# ADDENDUM NO. 3

Rochester City School District

Dr. Walter Cooper, School #10

March 7<sup>th</sup>, 2018

**8** EVENT LOBBY BENCH SEAT  
3/4" = 1'-0"

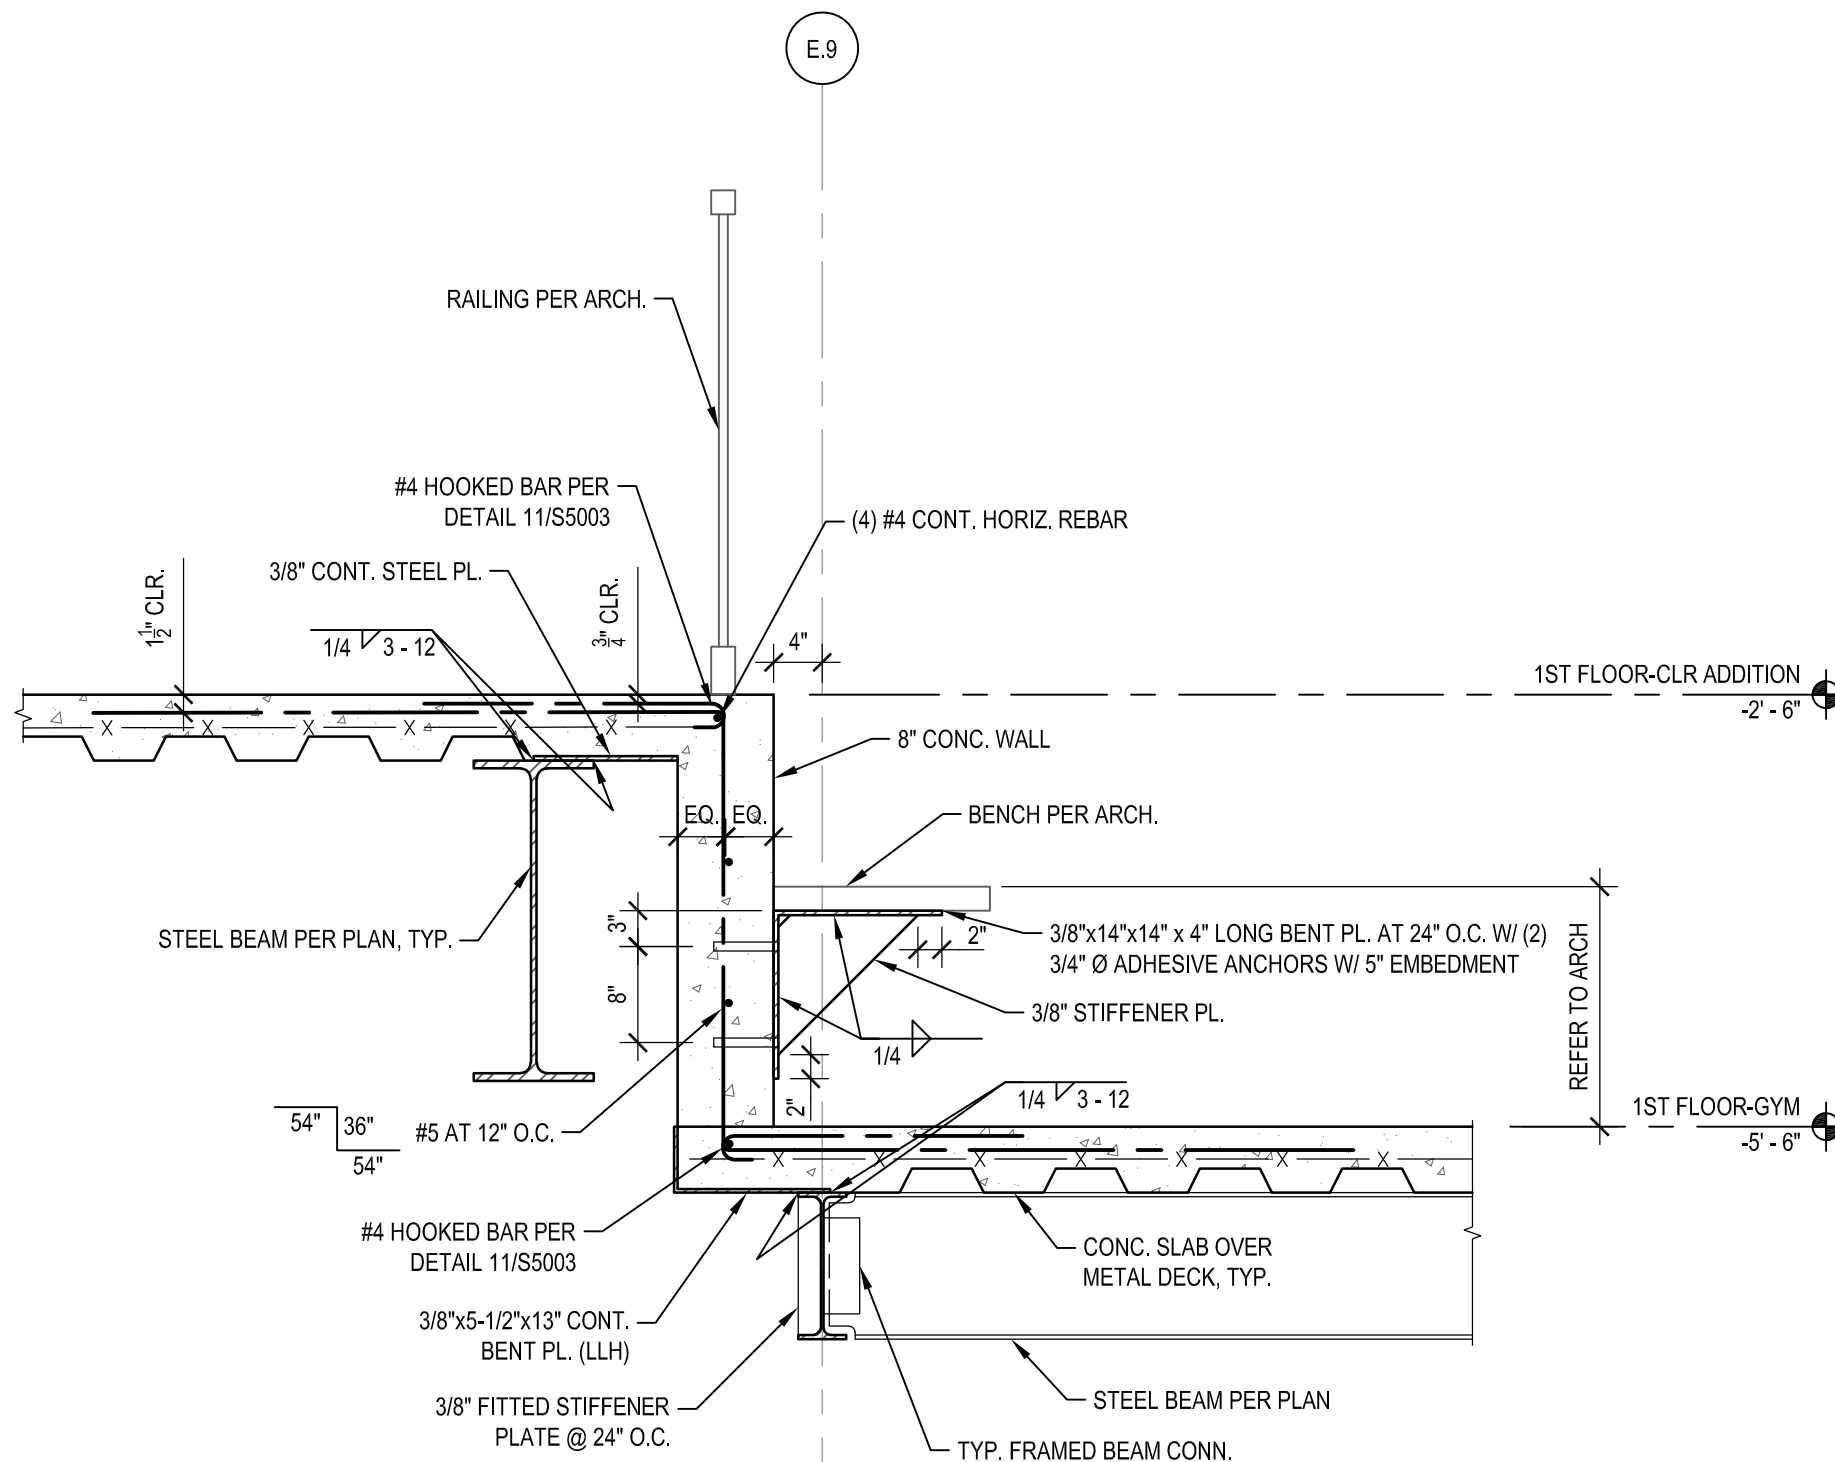
- Item AD3-51 **ADD** attached sketch "AD3-S010 – EVENT LOBBY STAIR," adding Detail 7 to Drawing S4001.
- Item AD3-52 **ADD** attached sketch "AD3-S011 – EVENT LOBBY BENCH SEAT," adding Detail 8 to Drawing S4001.
- Item AD3-53 **ADD** attached sketch "AD3-S012 – FRAMING AND MECHANICAL CHASE AT FLOOR CHANGE," adding Section 9 to Drawing S4001.

**7 CONCRETE RAMP**  
3/4" = 1'-0"

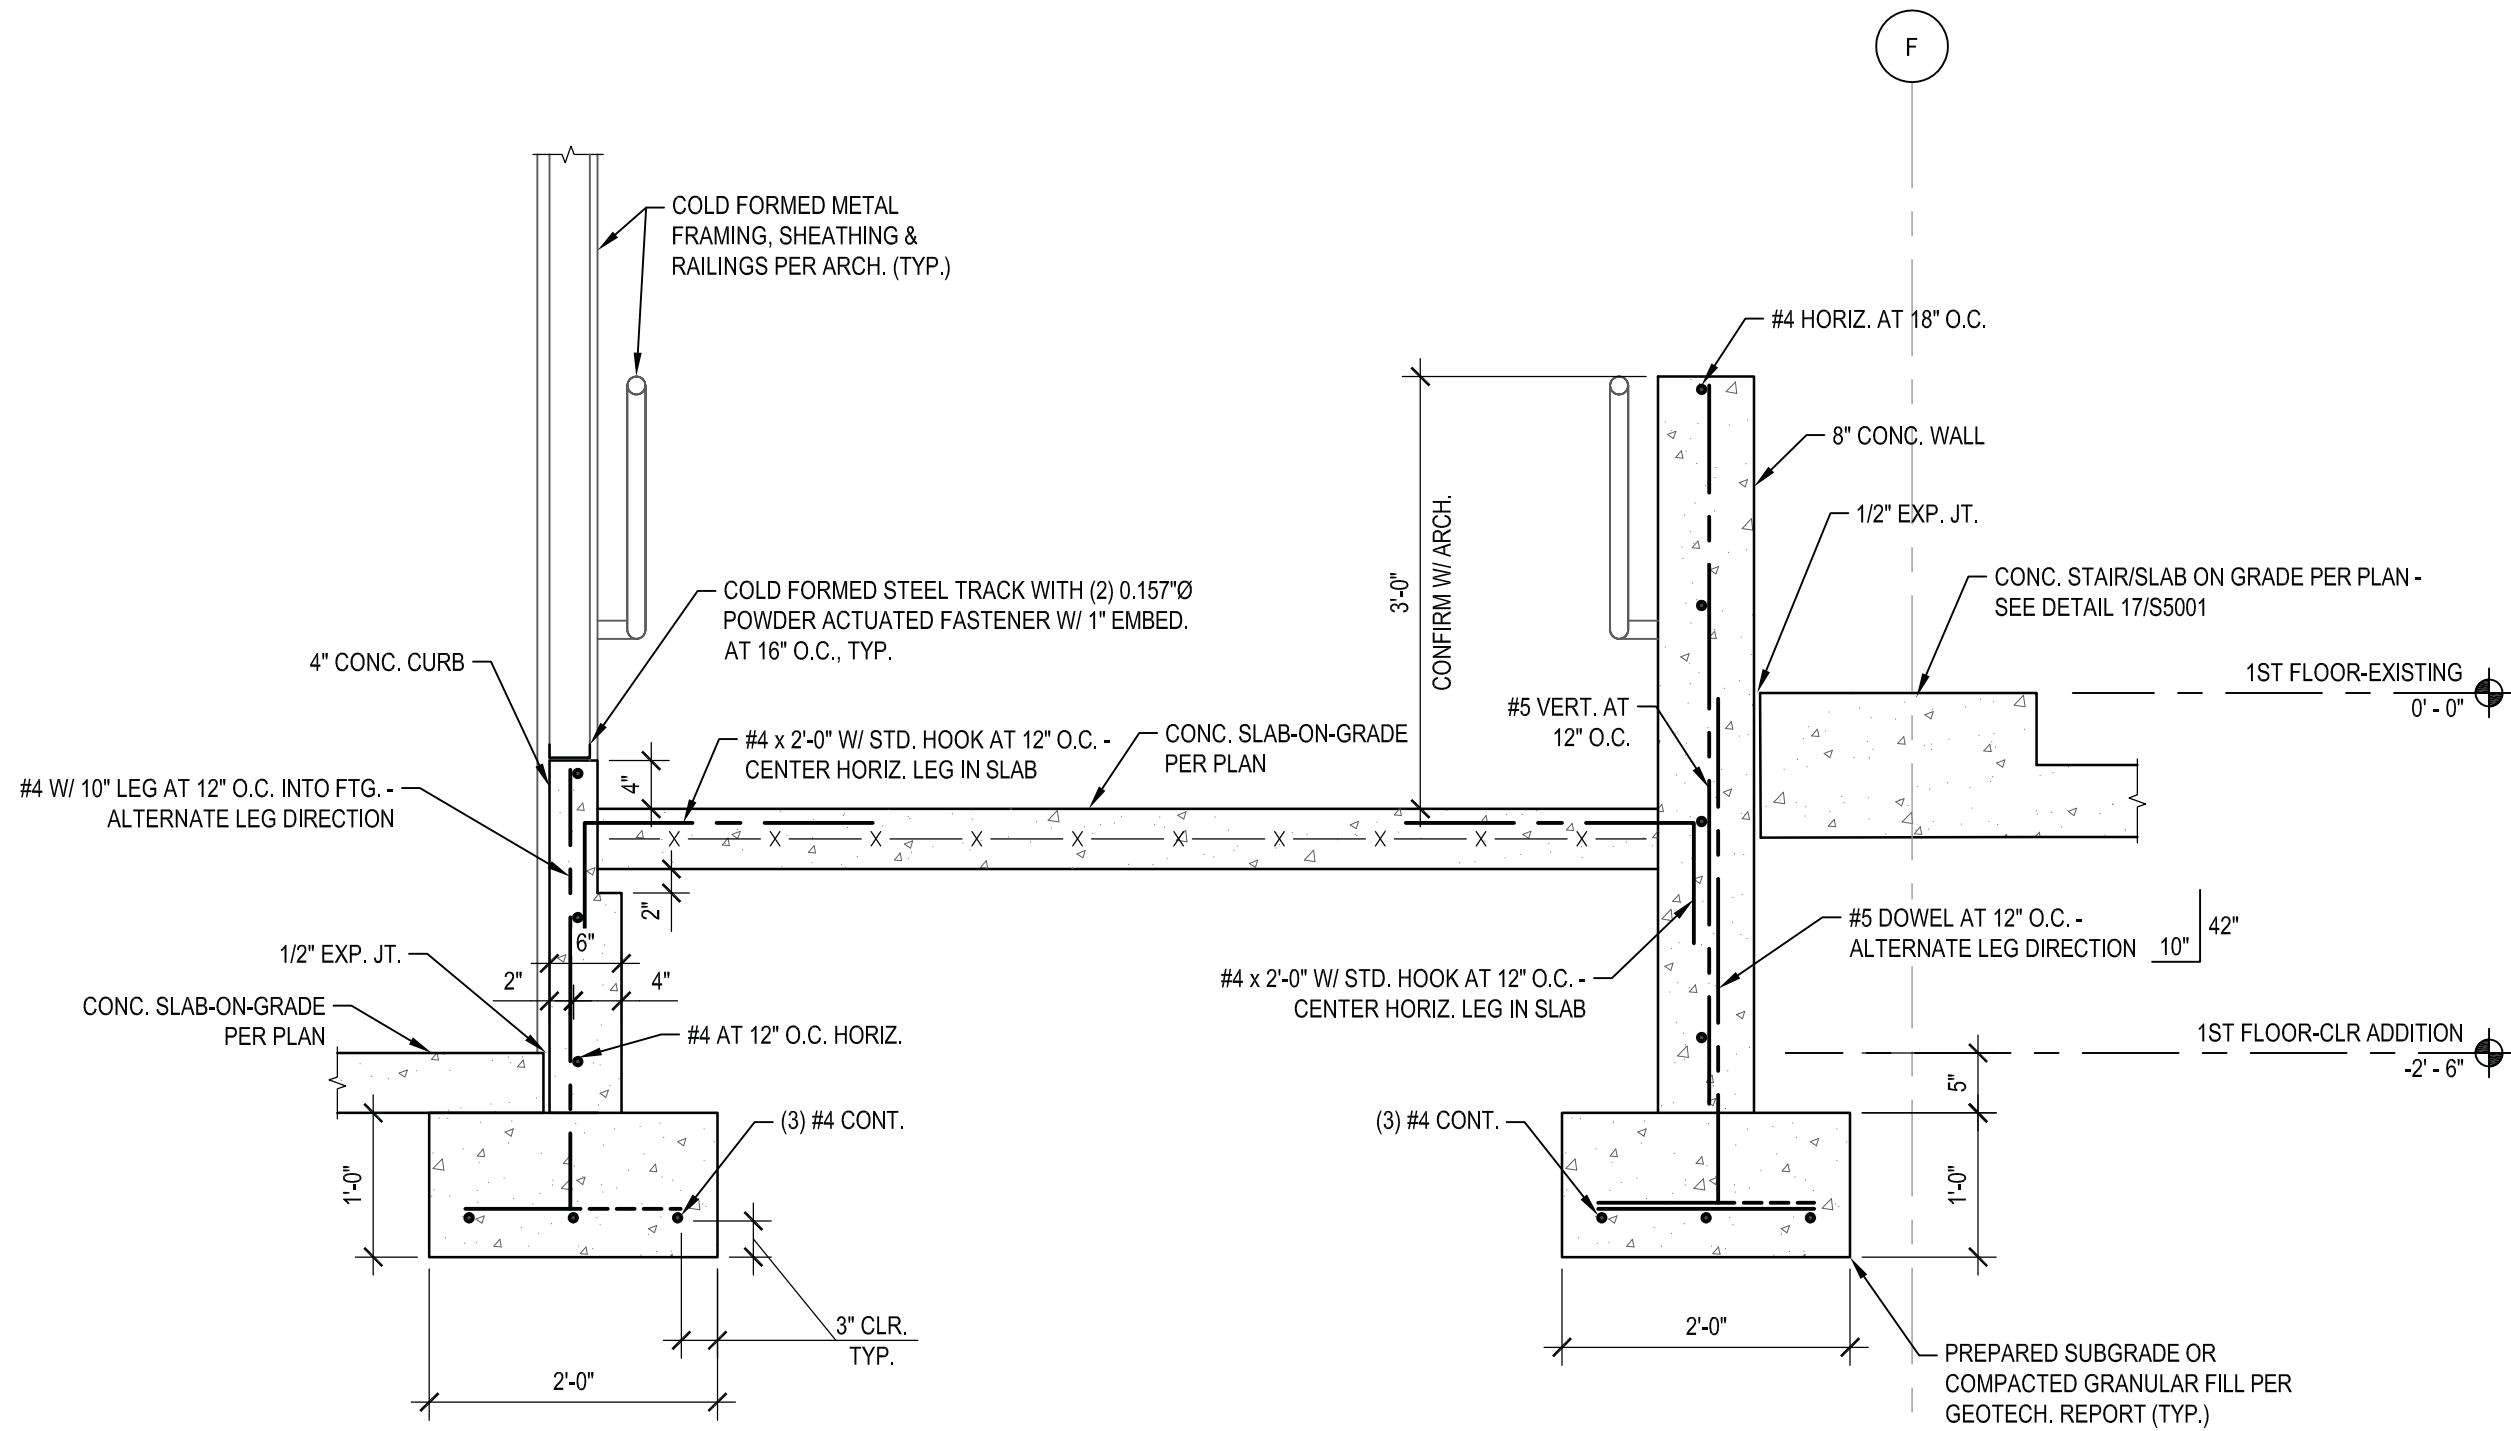
- Item AD3-54 **ADD** attached sketch "AD3-S013 – CONCRETE RAMP," adding Section 7 to Drawing S4002.

**17** TYPICAL CONCRETE STAIR ON GRADE  
N.T.S.

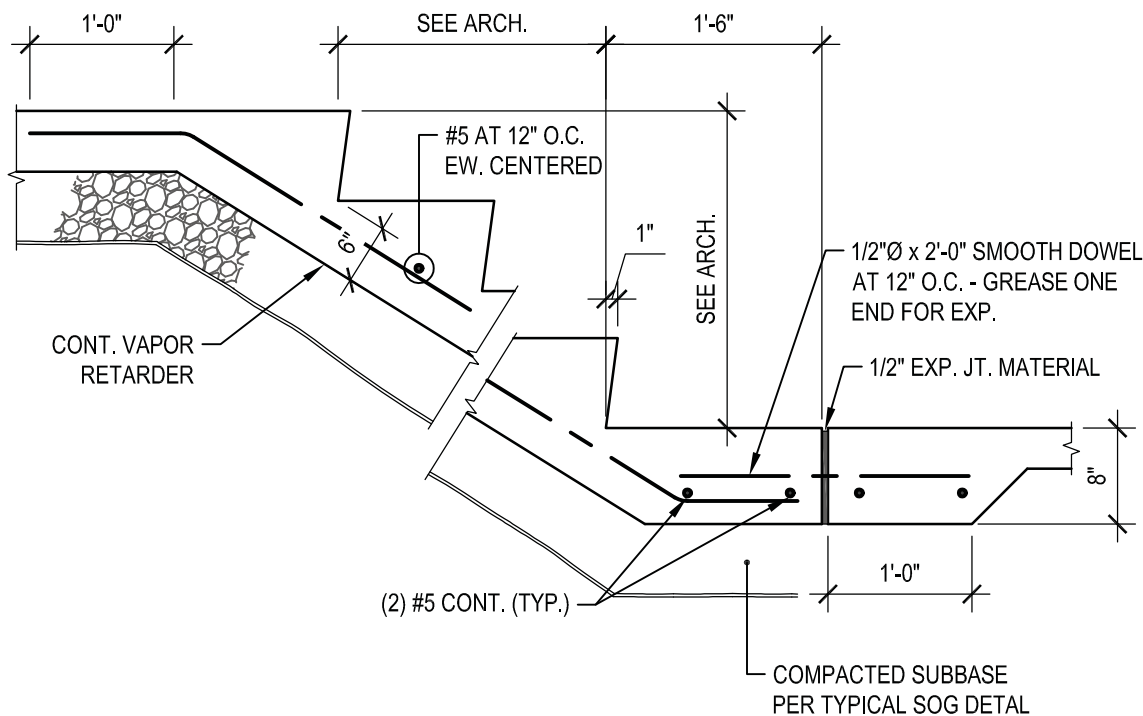
- Item AD3-57 **REVISE** "VAPOR BARRIER" noted in Detail 5 Note #1 to read "VAPOR RETARDER"  
Item AD3-58 **DELETE** the following top of footing reference from Detail 13:  
"TOP OF FOOTING REFER TO PLAN"  
Item AD3-59 **REVISE** Detail 13 footing width of "REFER TO PLAN" to read "2'-0" TYP."  
Item AD3-60 **ADD** attached sketch "AD3-S014 - TYPICAL CONCRETE STAIR ON GRADE," adding Detail 17 to Drawing S5001.

**1** TYPICAL STEEL COLUMN AT EXTERIOR WALL  
3/4" = 1'-0"

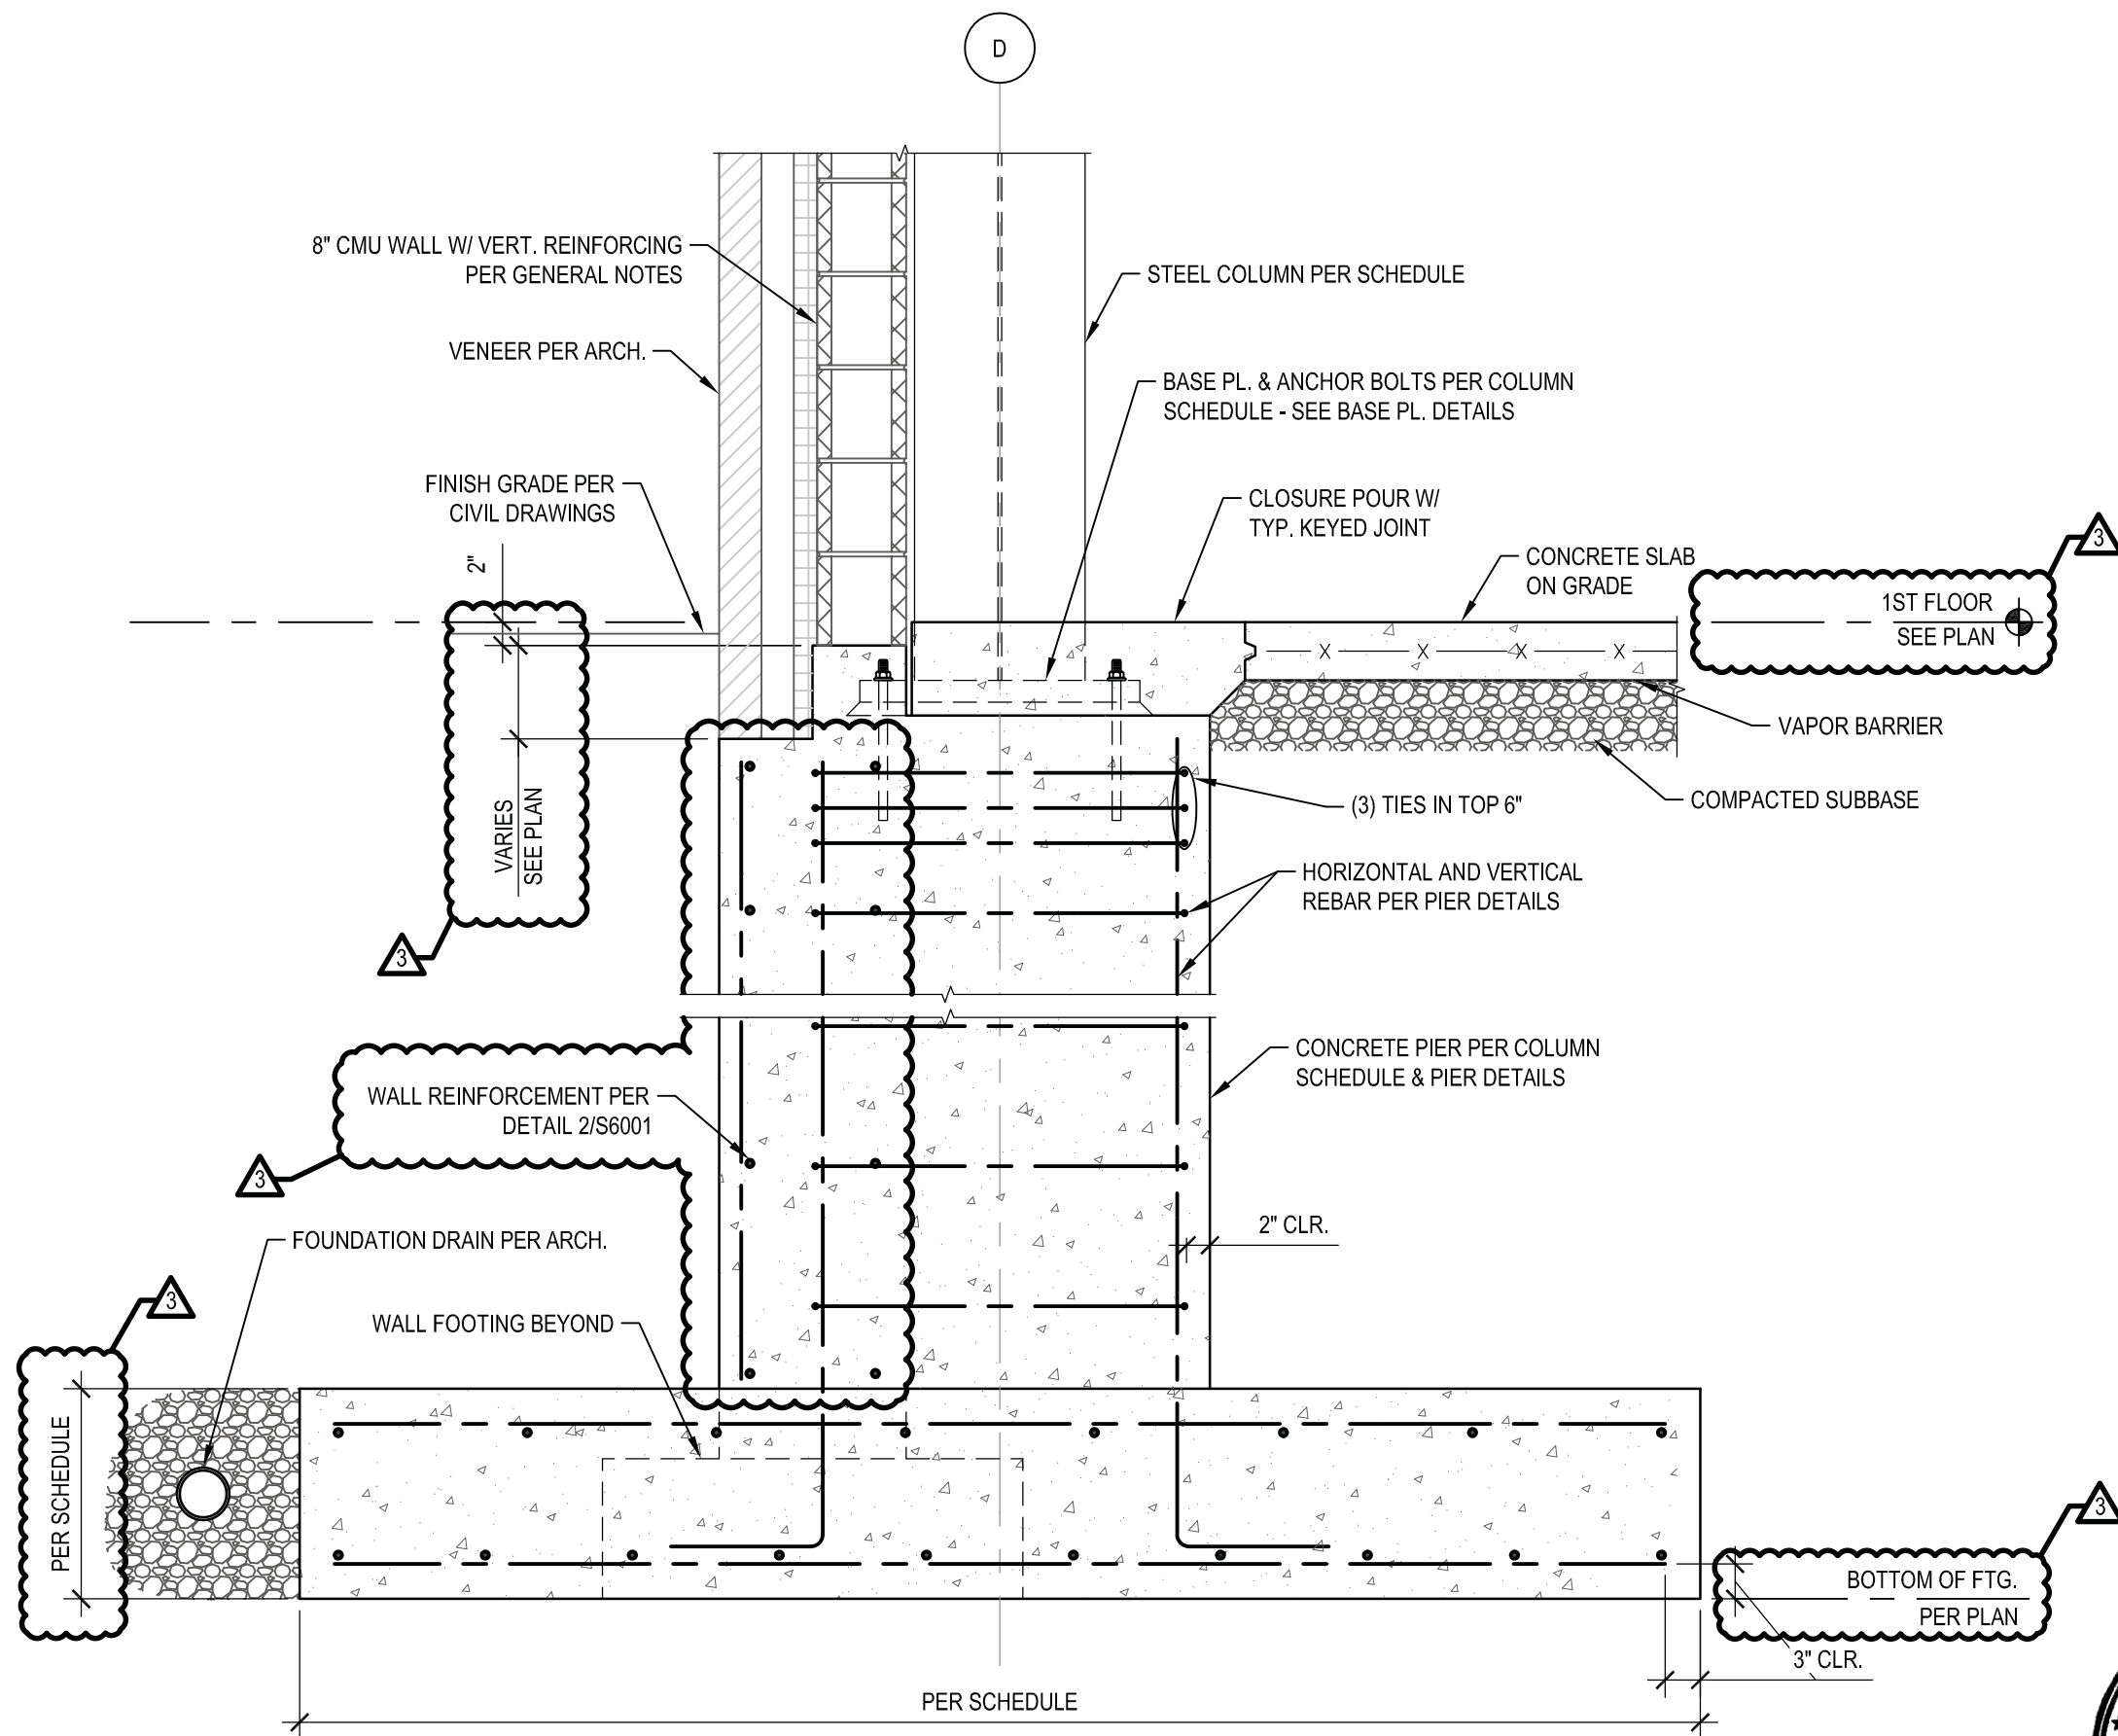
- Item AD3-68 **REPLACE** Detail 1 with attached sketch "AD3-S015 - TYPICAL STEEL COLUMN AT EXTERIOR WALL."  
Item AD3-69 **REVISE** Detail 2 footing depth dimensions of "1'-0"" to read "PER SCHEDULE"
